GULF STATES UTILITIES COMPANY

February 5, 1985
RBG- 20,079
File No. G9.5, G9.19.2
G9.20.6

River Bend Station - Unit 1
Docket No. 50-458

The attached information is being provided as requested by the Nuclear Regulatory Commission's Emergency Preparedness Licensing Branch (EPLB) for it's review and input to Safety Evaluation Report Section 13.1.

FIGURE 13.3-10
 GENERAL EMERGENCY—
 EMERGENCY ORGANIZATION
 RIVER BEND STATION
 FINAL SAFETY ANALYSIS REPORT
 AMENDMENT 15 NOVEMBER 1984

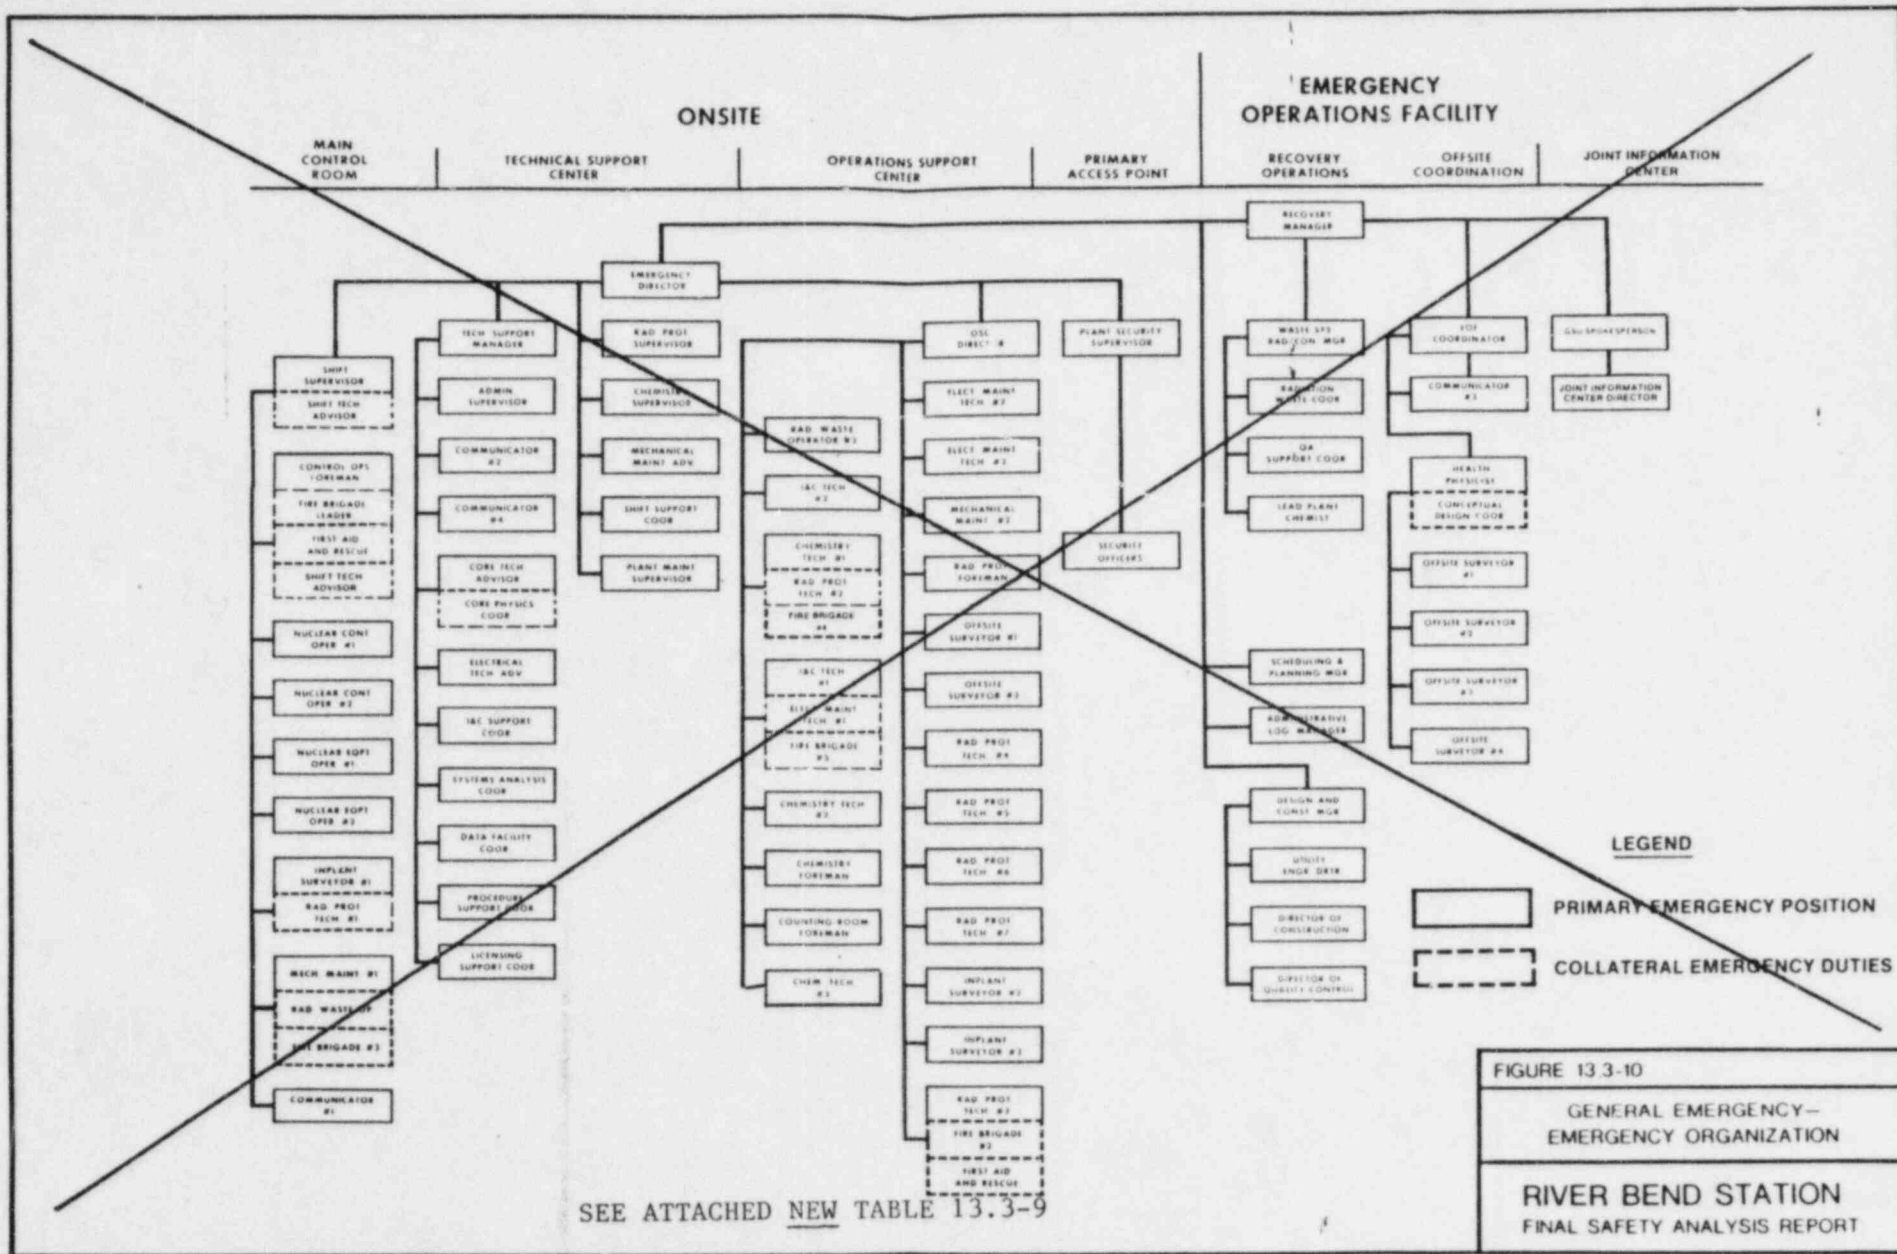
The Shift Technical Advisor's functions are performed by the Shift Supervisor as indicated in Table 13.3-5, Sheet 1, and Figures 13.3-7 through 13.3-10. An additional Radiation Protection Technician No. 3 is available on the operating shift. Health physics training is provided to the on-shift Chemistry Technician to enable him to provide health physics support for access control, personnel monitoring, and general health physics coverage. ~~Tables 13.3-5 and 13.3-6, Figures 13.3-7, 13.3-8, 13.3-9, and 13.3-10, and Appendix A have been revised accordingly.~~

EMERGENCY OFFSITE COMMUNICATIONS

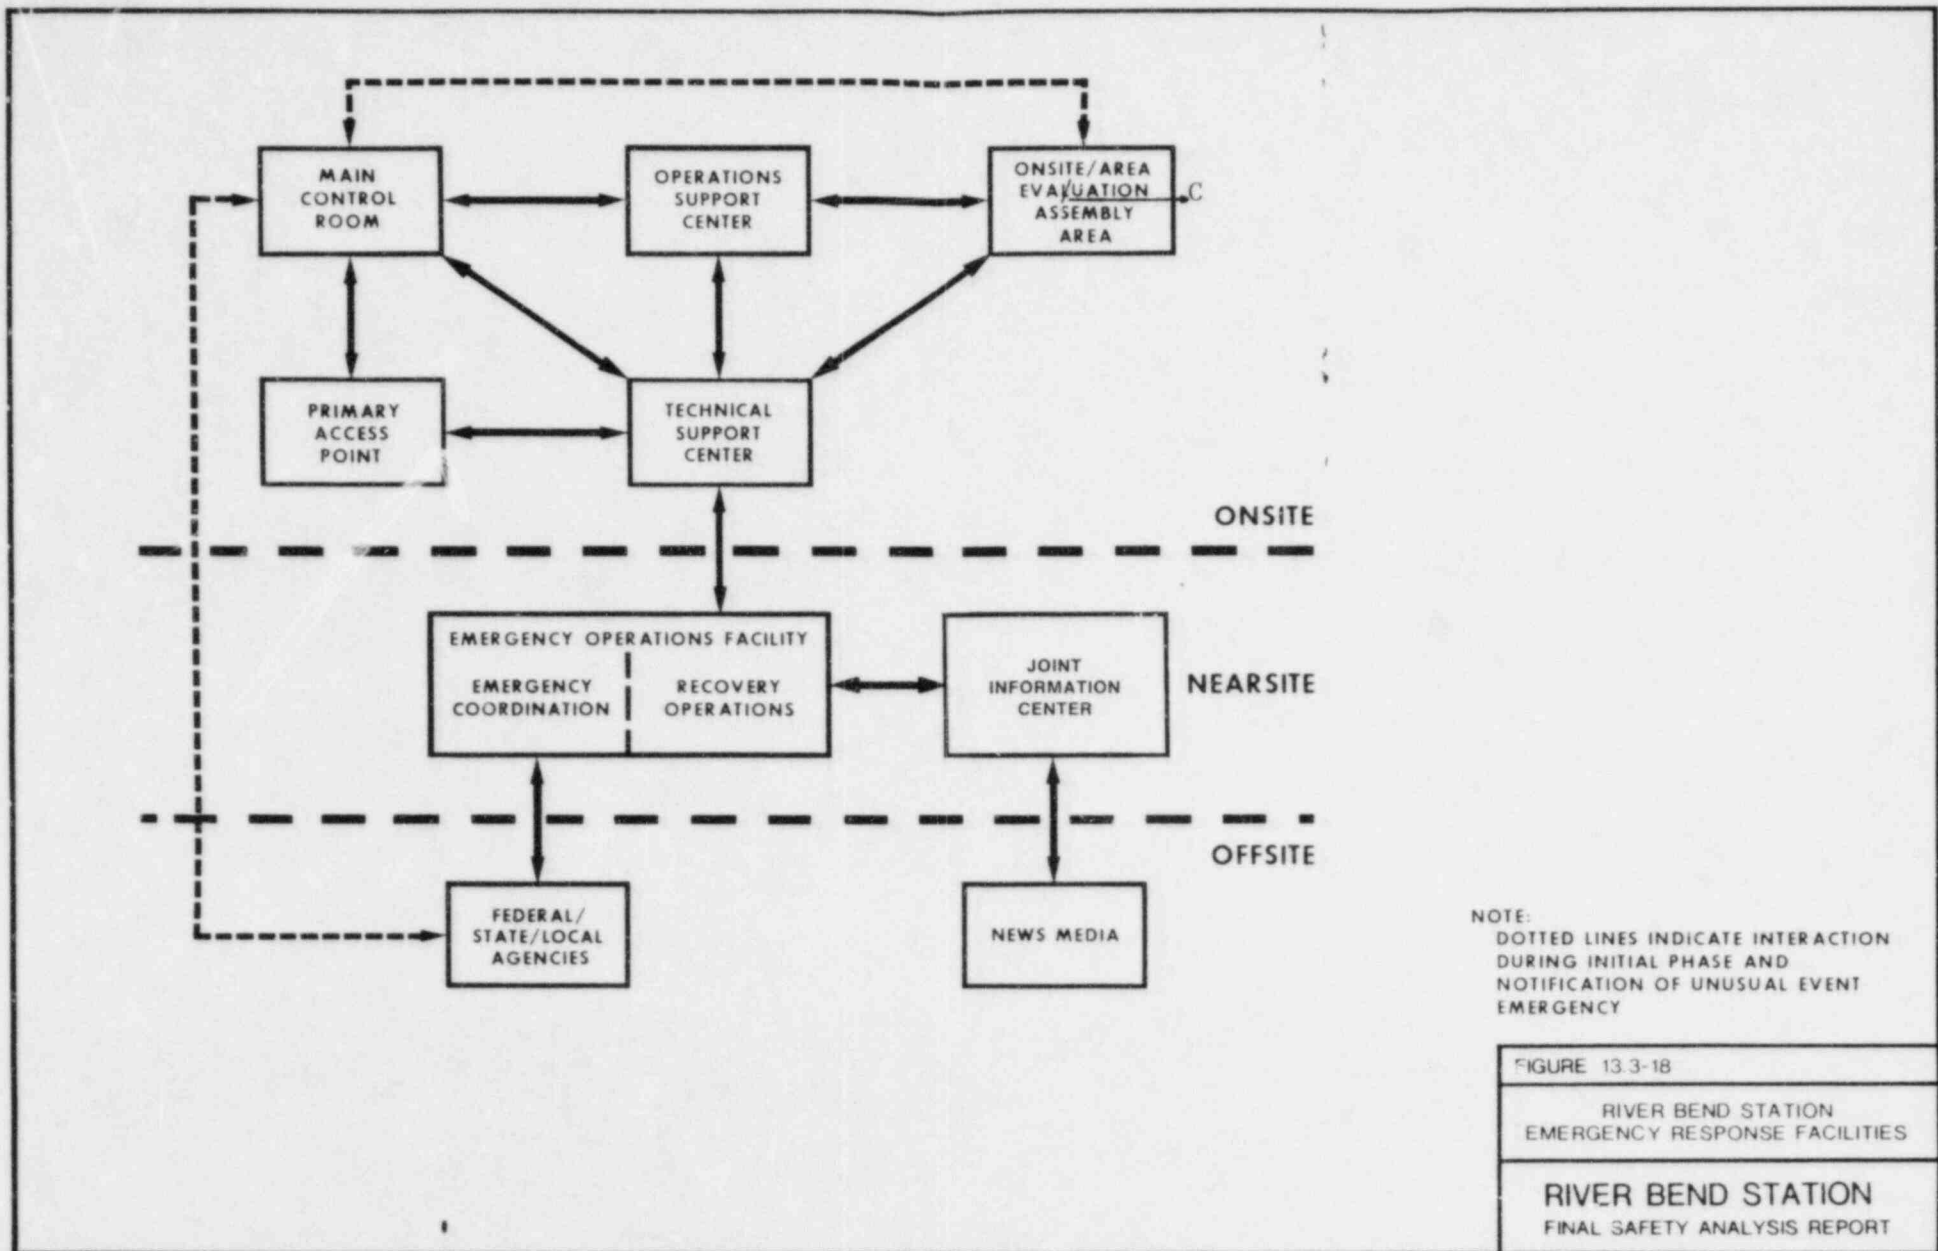
Section 13.3.5.2 has been revised to indicate that meteorological information is accessed via computer CRTs by the TSC and EOF. Communication links to the NRC (as illustrated in revised Figures 13.3-17 and 13.3-19) are available to relay information to the NRC from any of the above centers.

OPERATION SUPPORT
CENTER - FLOOR PLAN

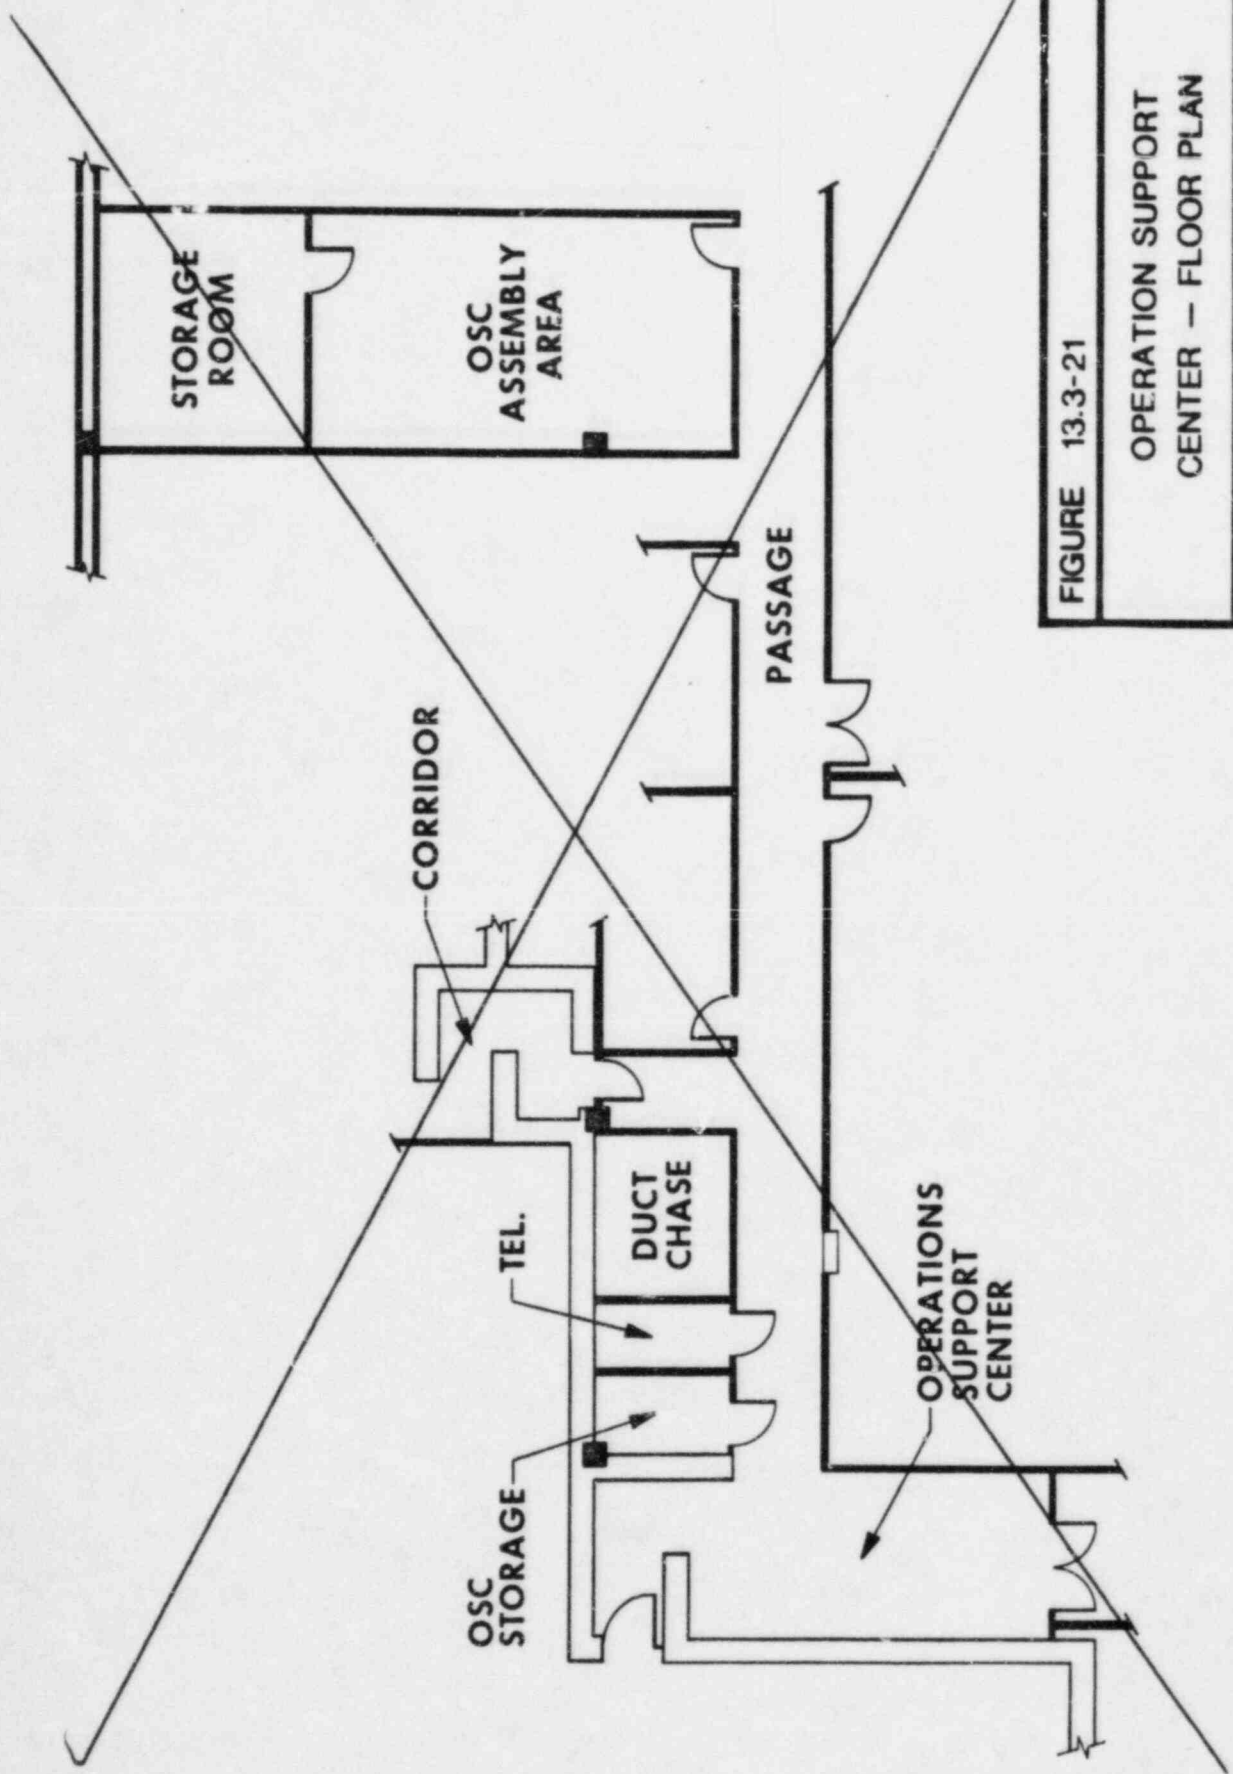
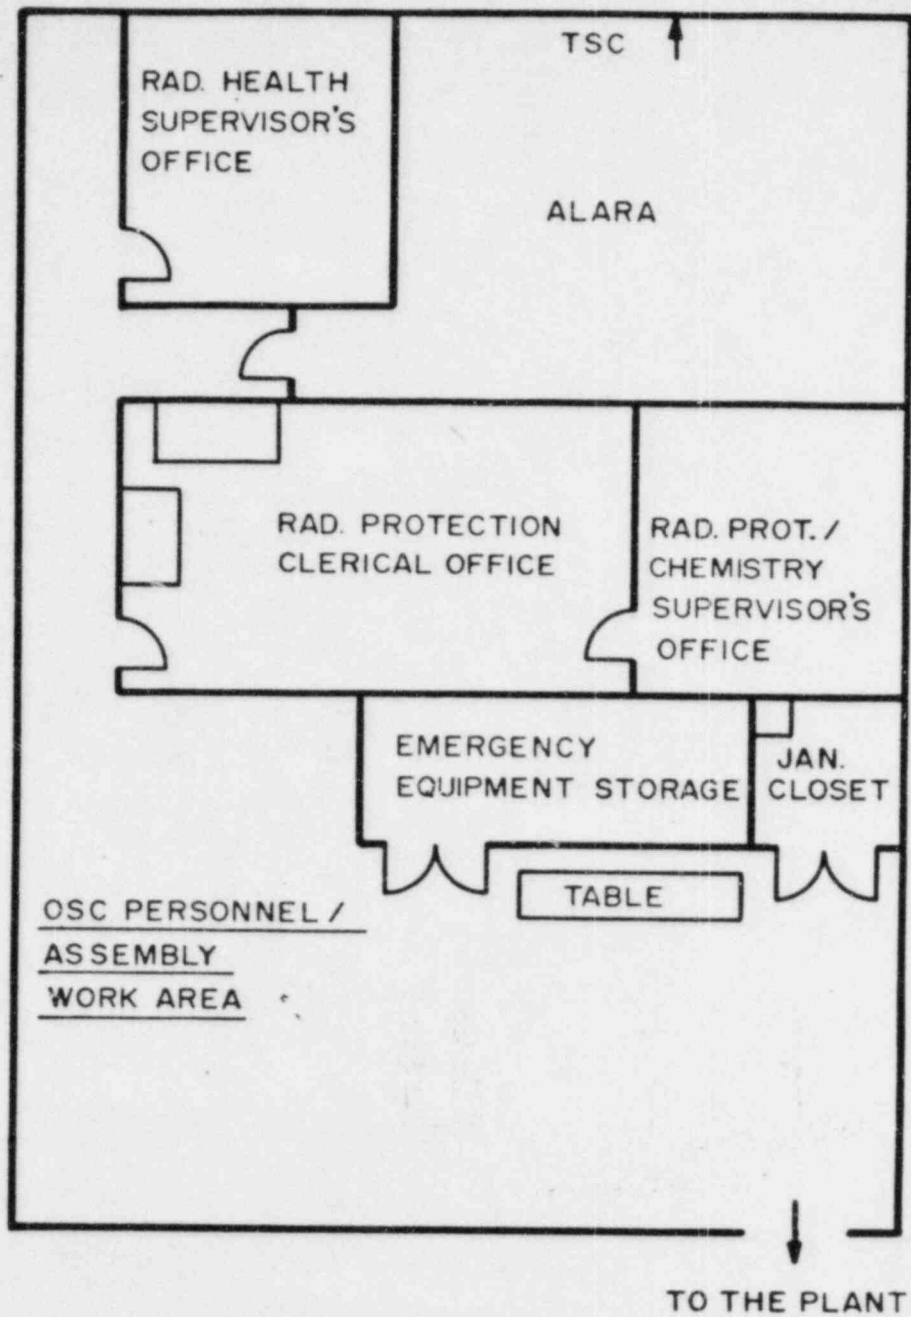
4 | The OSC will be located in the Services Building. The floor plan is shown in Figure 13.3-21. There will be direct communications between the OSC, Main Control Room, TSC, and EOF. If the OSC is evacuated, the TSC will serve as a backup until the OSC is determined to be habitable.

SEE NEW FIGURE 13.3-21 ATTACHED
